**PCN# : P617AAB**  
**Issue Date : Feb. 15, 2016**

**Information Only Notification**

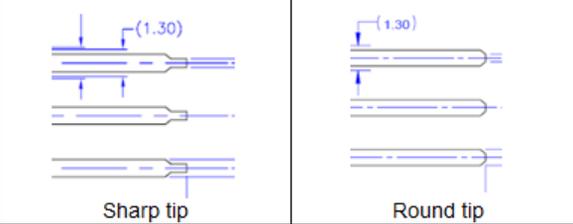
Description of Change (From) :

TO220 devices manufacturing using intermediate distribution frame(Sharp tip).

Description of Change (To) :

TO220 devices manufacturing using Jedec single strand frame(Round tip).

REF	DESCRIPTION	FSSZ TO220 JEDEC IDF Line FSCD0242-01(Before)			FSSZ TO220 JEDEC Single Strand FSZD-3-0075(After)		
		MIN	NOM	MAX	MIN	NOM	MAX
A	Package thickness	4.547	4.572	4.597	4.547	4.572	4.597
A1	Heatsink thickness	1.271	1.296	1.321	1.271	1.296	1.321
A2	Lead distance from plane	2.630	2.655	2.680	2.630	2.655	2.680
b	Lead mounting width	0.788	0.838	0.888	0.788	0.838	0.888
b2	Lead stand off width	1.250	1.400	1.550	1.250	1.400	1.550
c	Lead thickness	0.382	0.407	0.432	0.382	0.407	0.432
D	Package length from top heat sink	14.952	14.977	15.002	14.952	14.977	15.002
D1	Package height	8.662	8.687	8.712	8.662	8.687	8.712
D2	Heatsink length	12.660	12.710	12.760	12.660	12.710	12.760
E	Package width	10.160	10.260	10.360	10.160	10.260	10.360
E1	Back metal heat sink width	8.570	8.620	8.670	8.570	8.620	8.670
e	Lead pitch	2.515	2.540	2.565	2.515	2.540	2.565
e1	Total lead pitch	5.055	5.080	5.105	5.055	5.080	5.105
H1	Heatsink height	6.240	6.290	6.340	6.240	6.290	6.340

L	lead length	13.169	13.194	13.219	13.169	13.194	13.219
L1	Lead stand off length	3.680	3.730	3.780	3.680	3.730	3.780
P	Slot diameter	3.811	3.836	3.861	3.811	3.836	3.861
Q	Slot center distance	2.710	2.760	2.810	2.710	2.760	2.810
aaa	Heatsink position tolerance	---	---	---	---	---	---
bbb	Lead position tolerance	---	---	0.050	---	---	0.050
Lead Tip Shape

The change is for package simplification and supply flexibility improvement. Products will continue to meet all data sheet parameters and mechanical dimensions. Quality and reliability will remain at the highest standards already demonstrated with Fairchild's existing TO220 products.
